Amhurst Elevated Storage Tank Rehabilitation Project - RFCSP
Solicitation No.: CO-00505
SAWS No.: 21-0128

ADDENDUM 2
March 4, 2021

SAN ANTONIO WATER SYSTEM
AMHURST ELEVATED STORAGE TANK REHABILITATION
SITE CIVIL
EXISTING SITE AND DEMOLITION PLAN

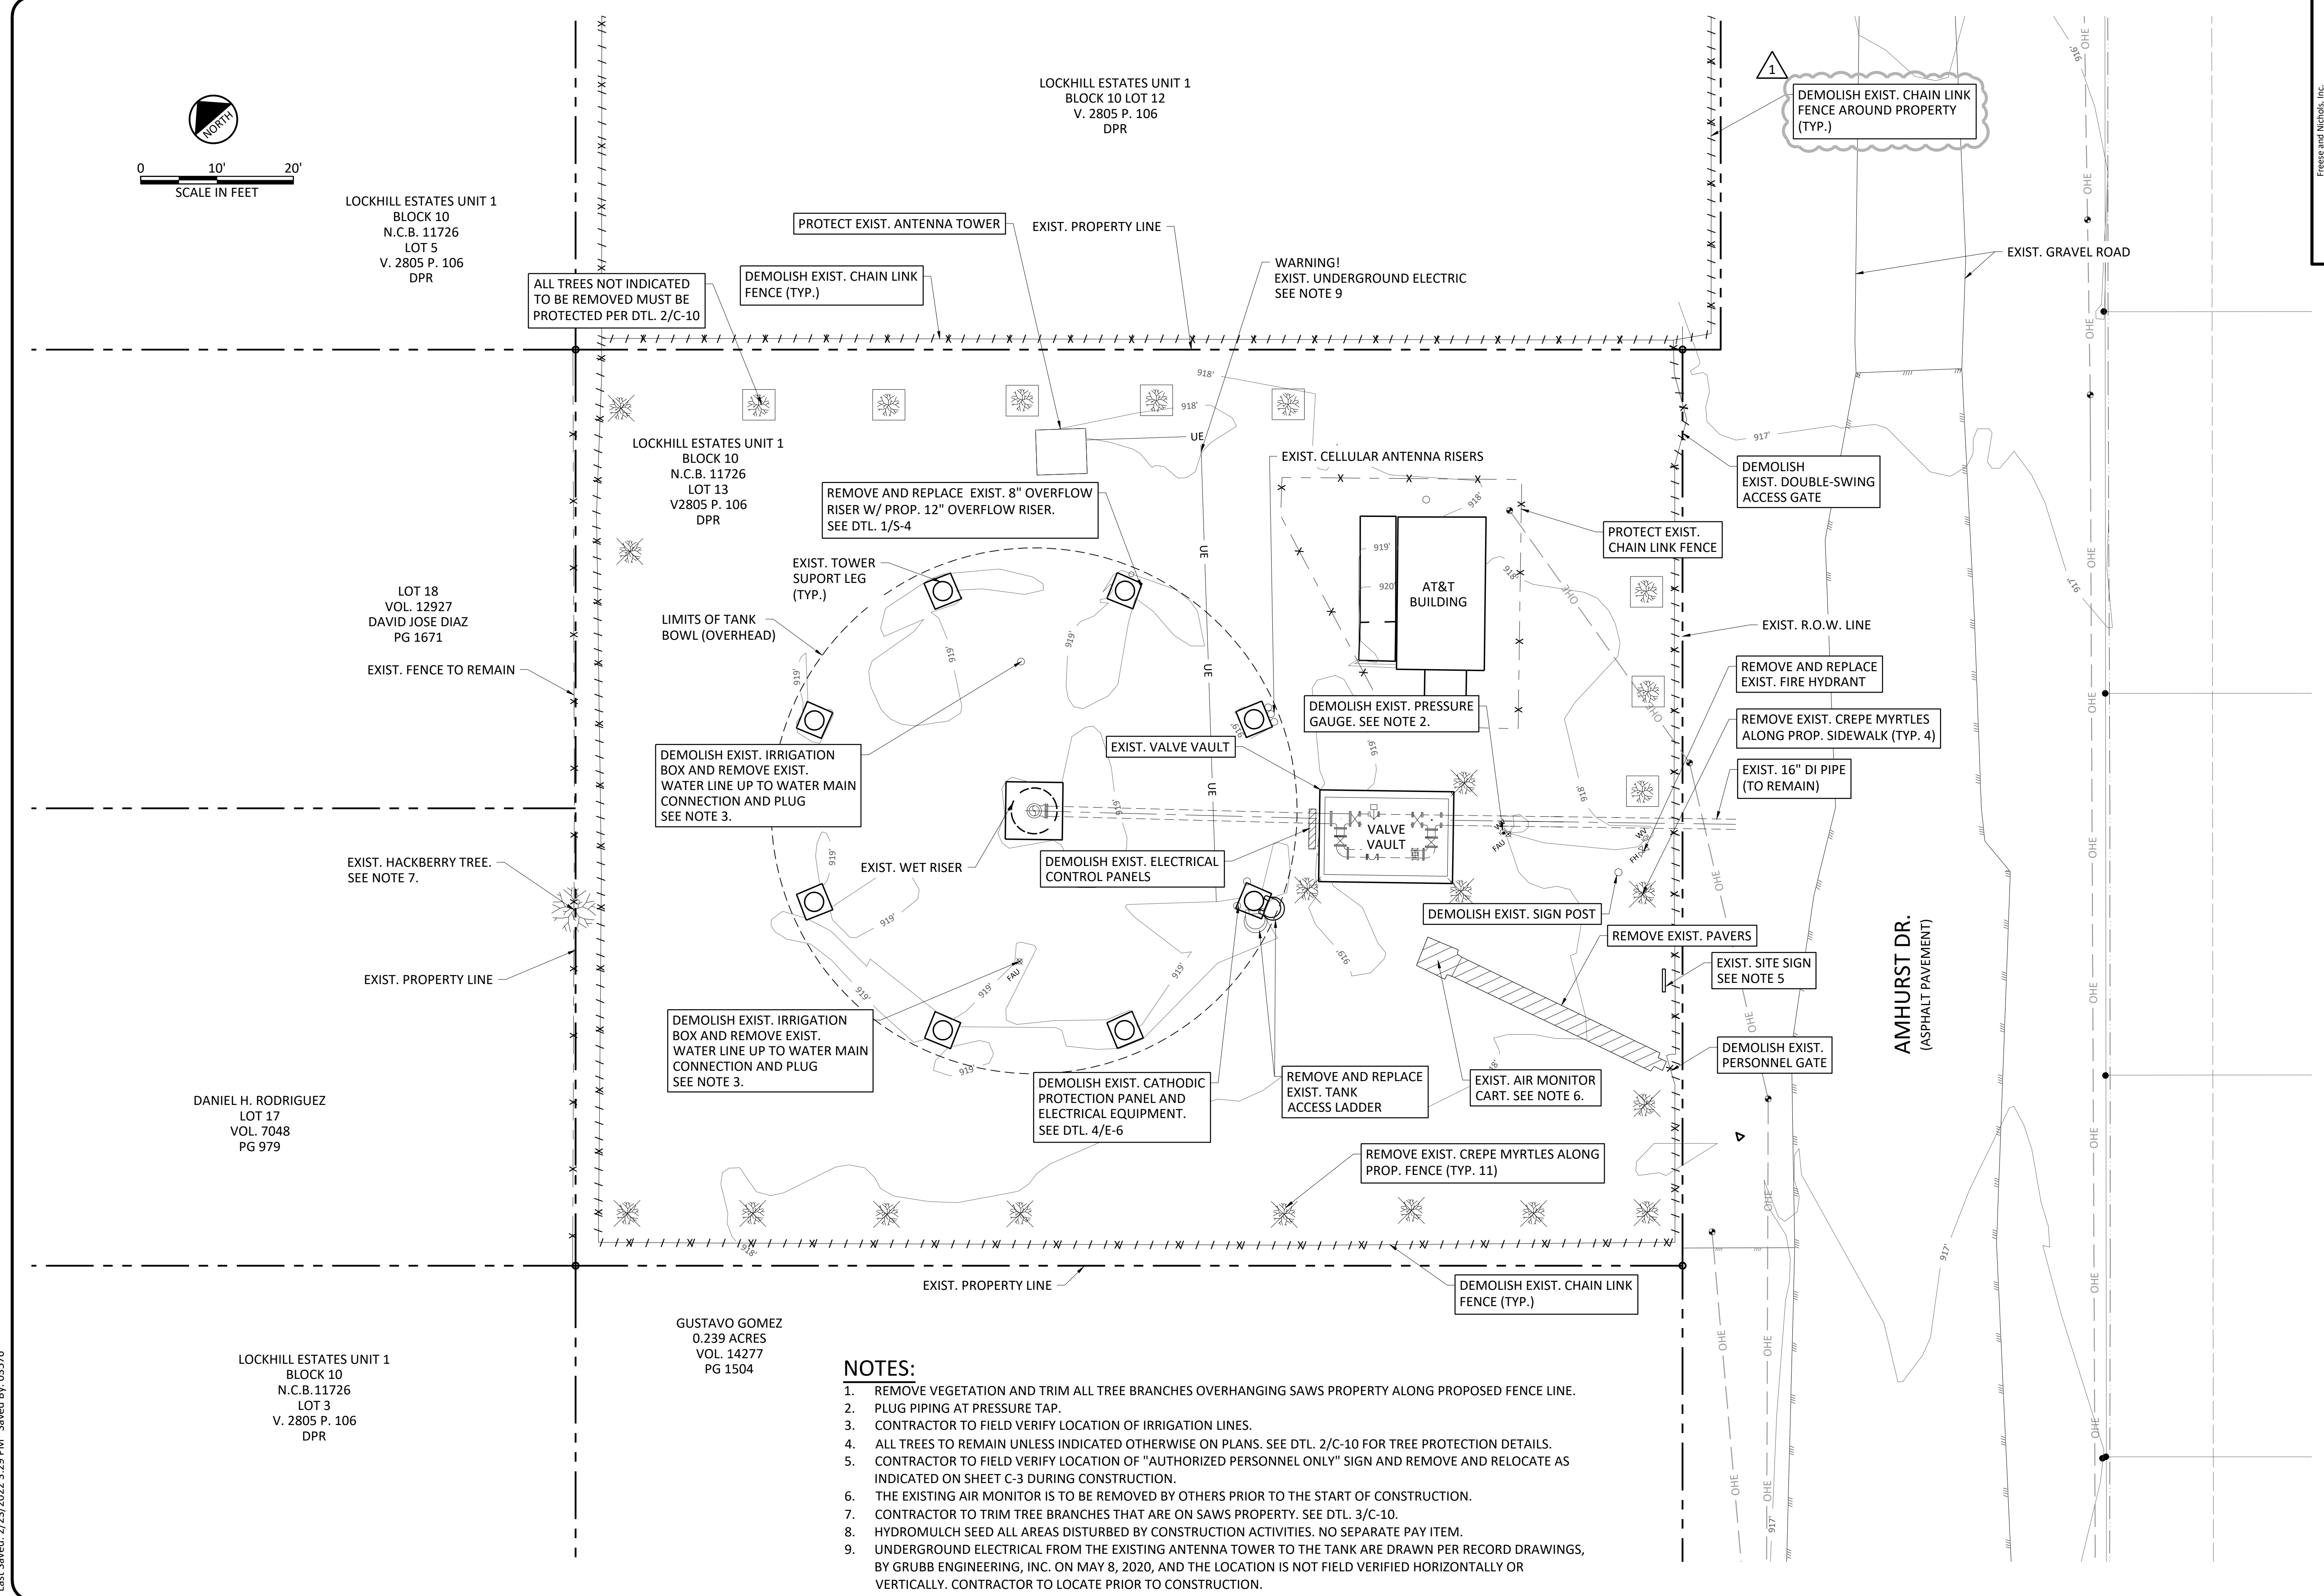
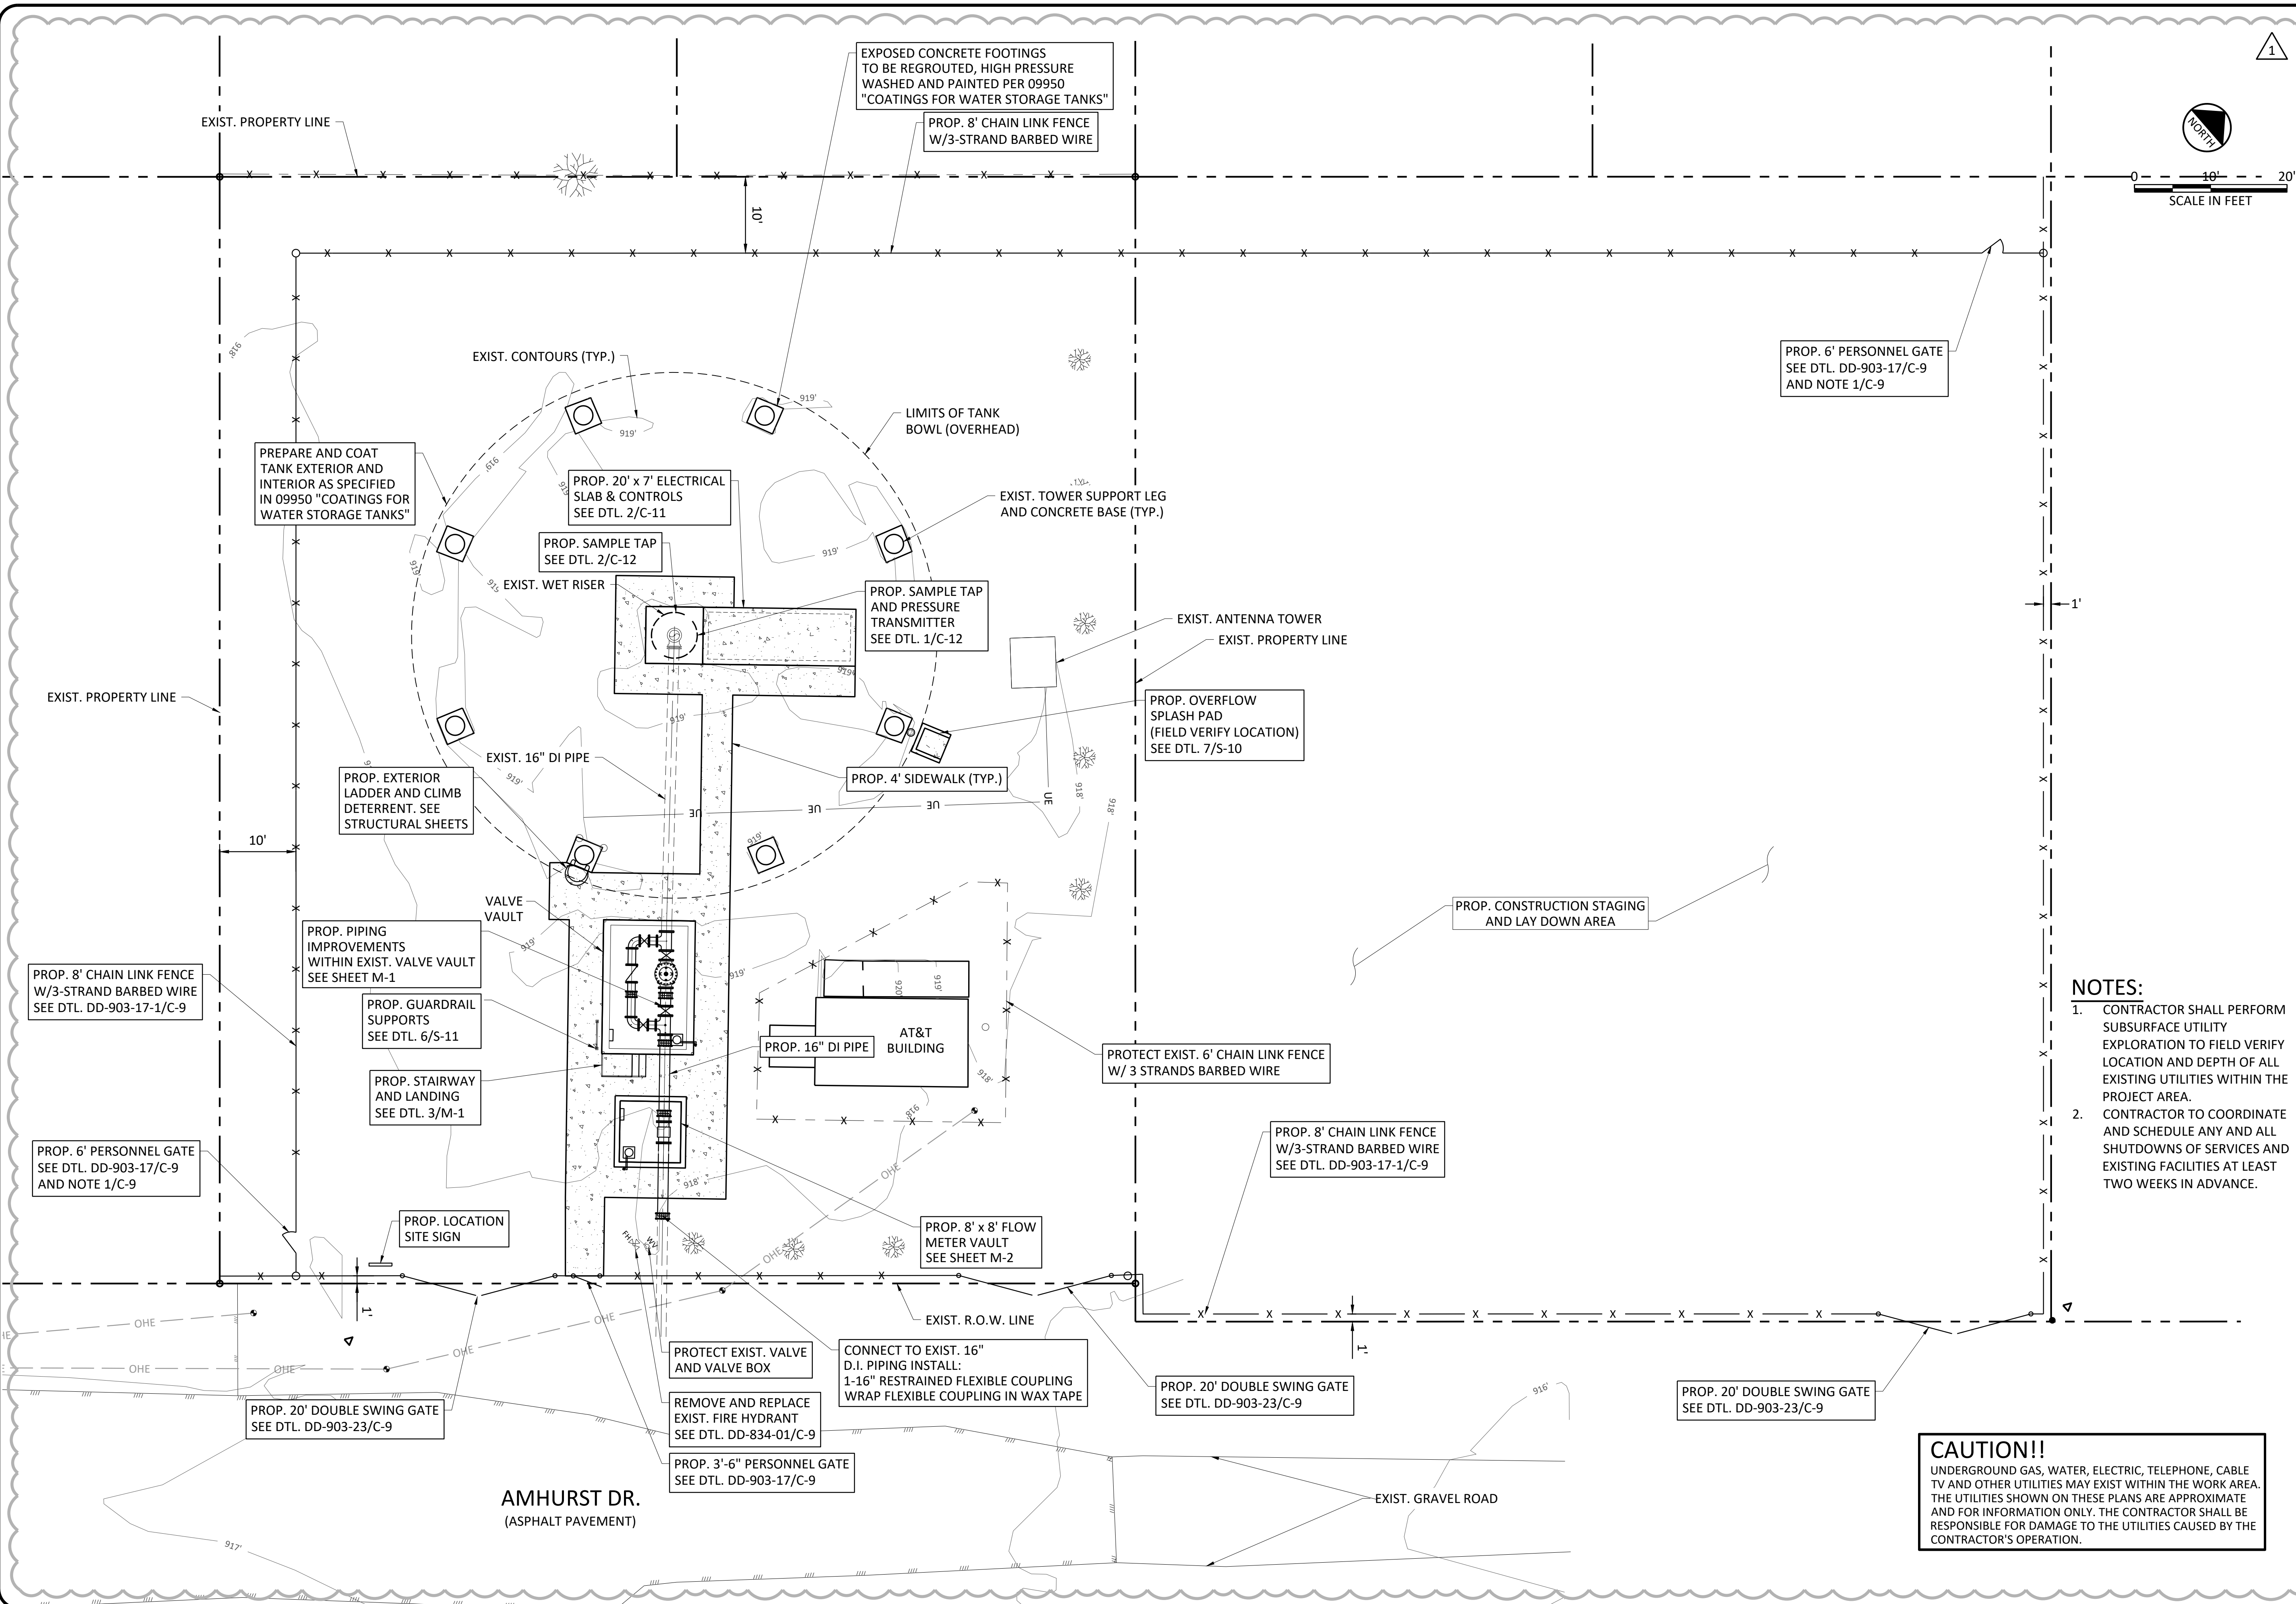
NO.	ISSUE	BY	DATE	FRN JOB NO.	SWB21382
DESIGNED	RWR		2/23/2022	DATE	2/23/2022
DRAWN	RWR			REVISED	EWL
CHECKED	CAK			FILE NAME	WTU-AMH-DEMO-PL.dwg
ADDENDUM NO. 2 - FENCE REVISIONS		RWR	03/04/22	REVISIONS	
VERIFY SCALE				CHECKED	CAK
Bar is one inch on original drawing. If not one inch on this sheet, adjust scale.

SAN ANTONIO WATER SYSTEM
AMHURST ELEVATED STORAGE TANK REHABILITATION
 SITE CIVIL
PROPOSED SITE PLAN

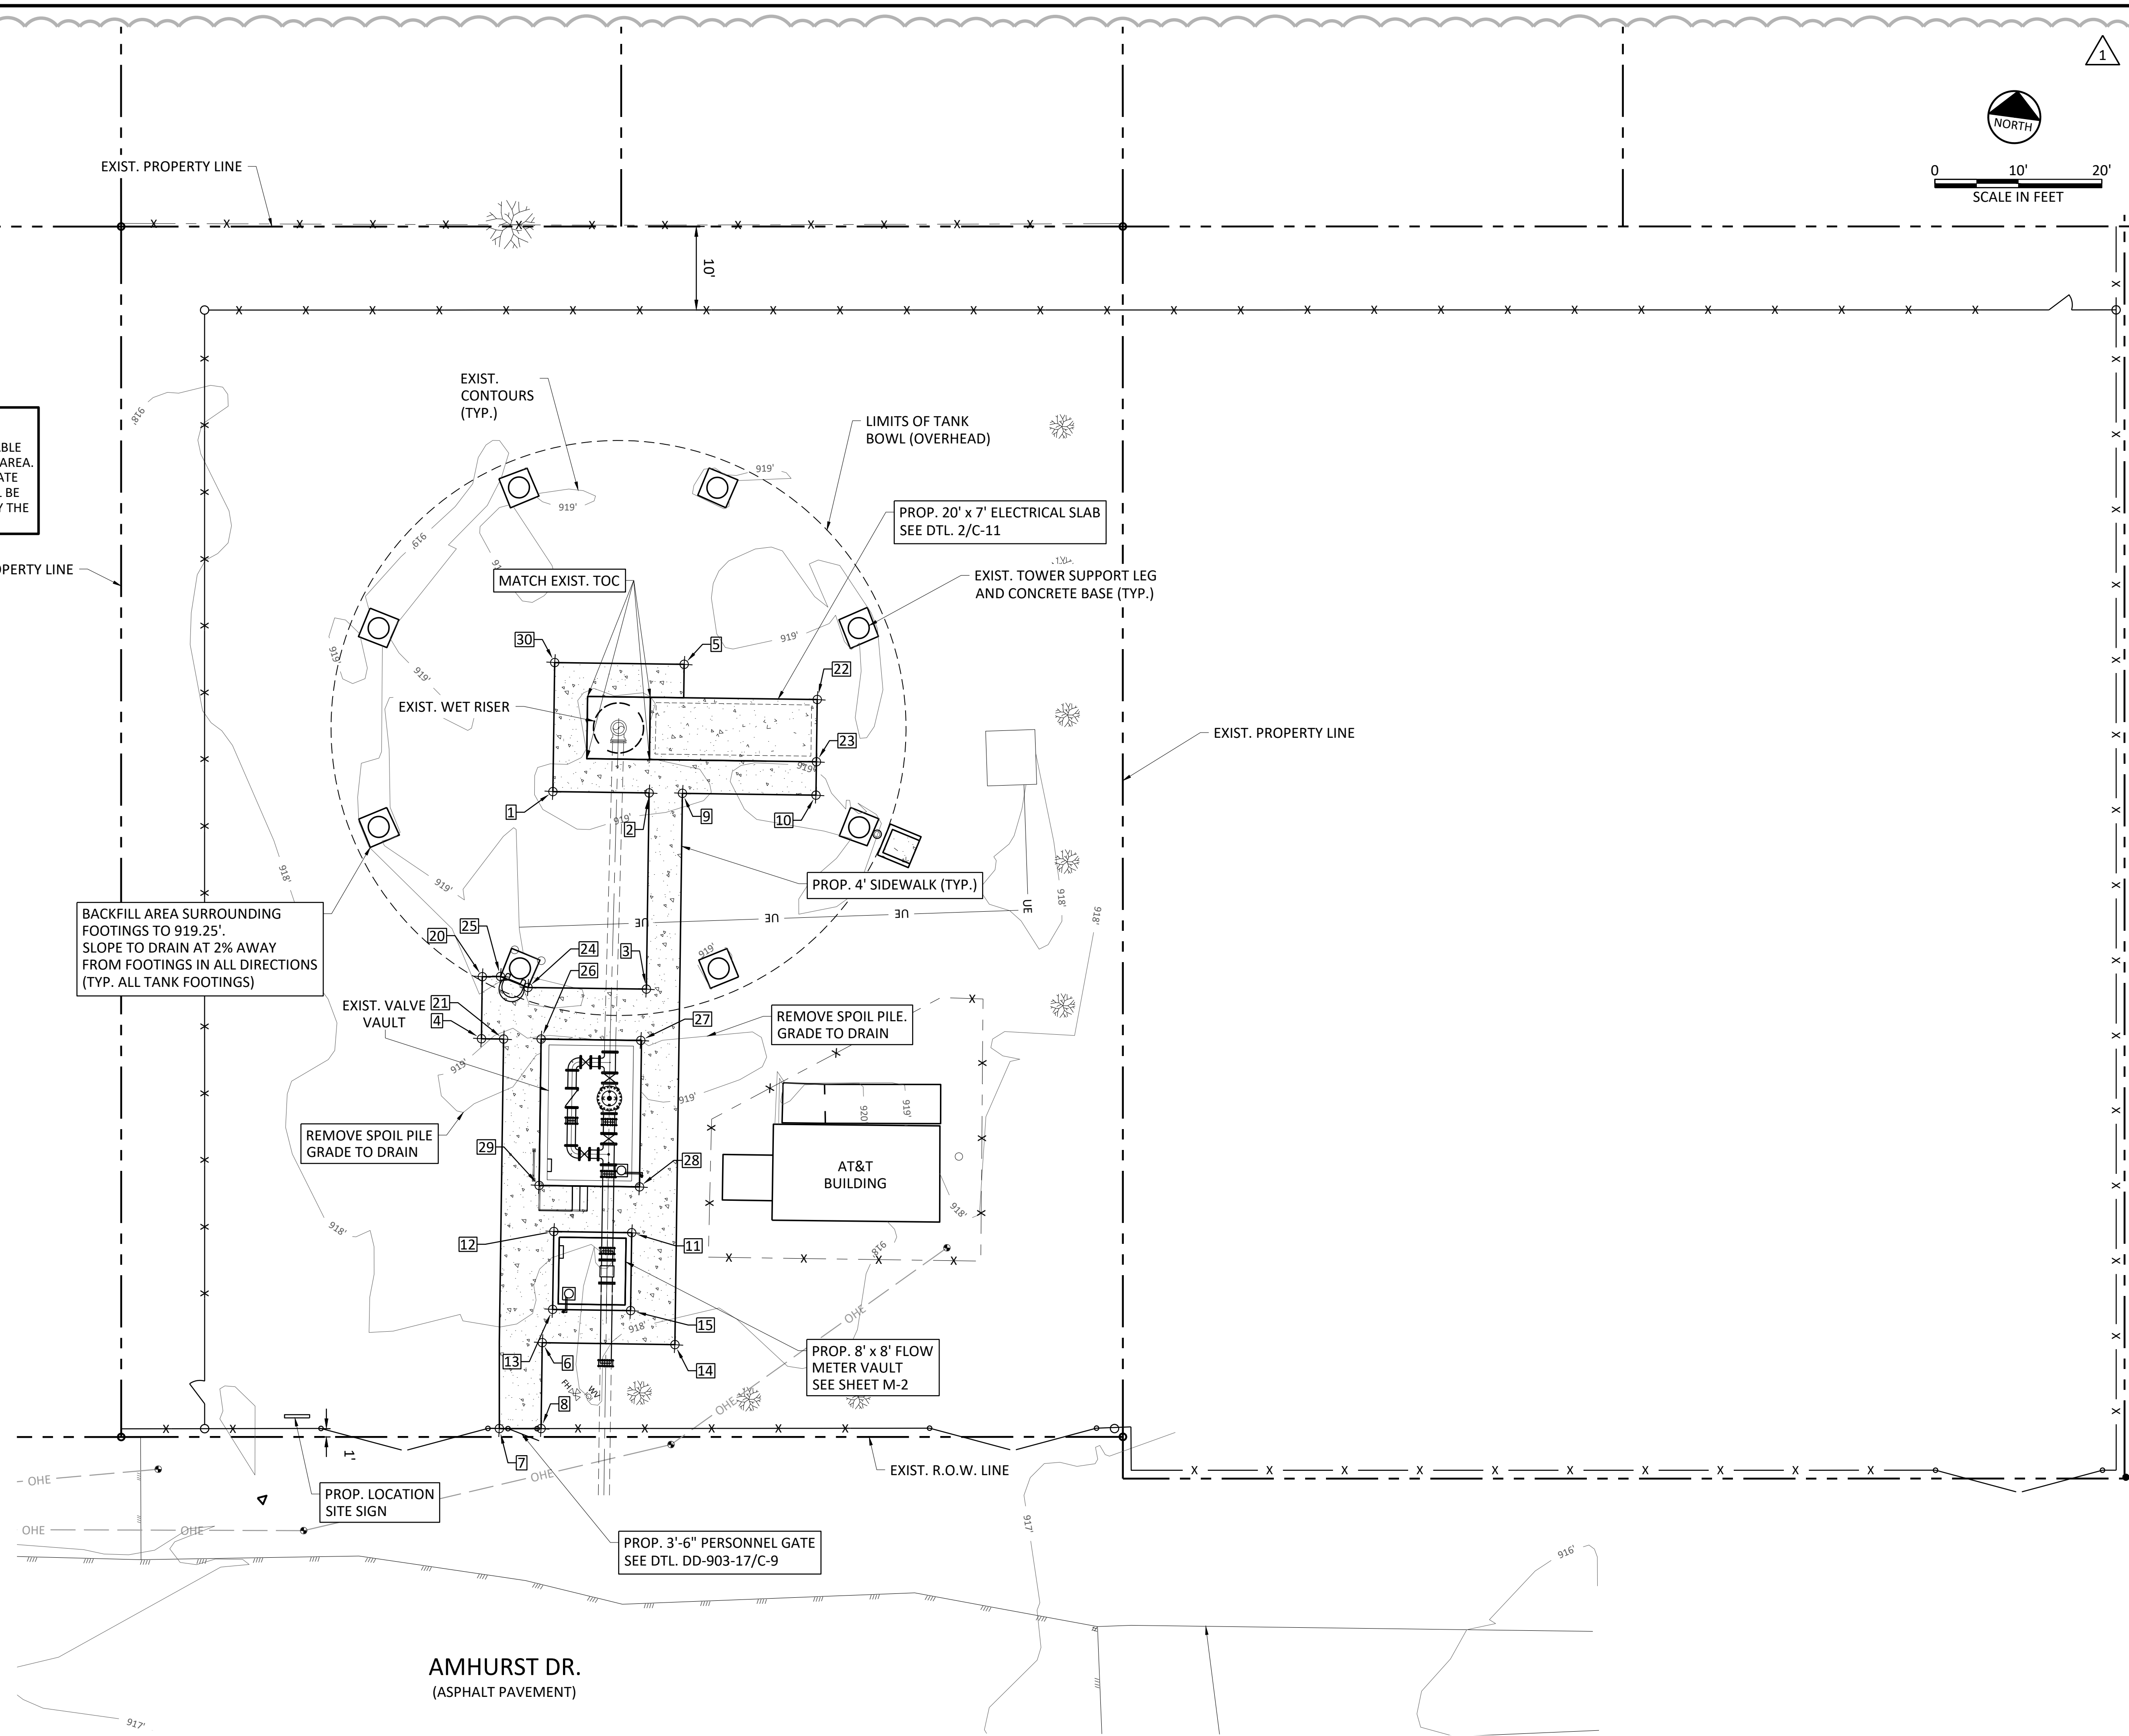
ADDENDUM NO.	VERIFY SCALE	FILE NAME
2 - FENCE REVISIONS	1	WTU-AMH-SITE-PI01.dwg
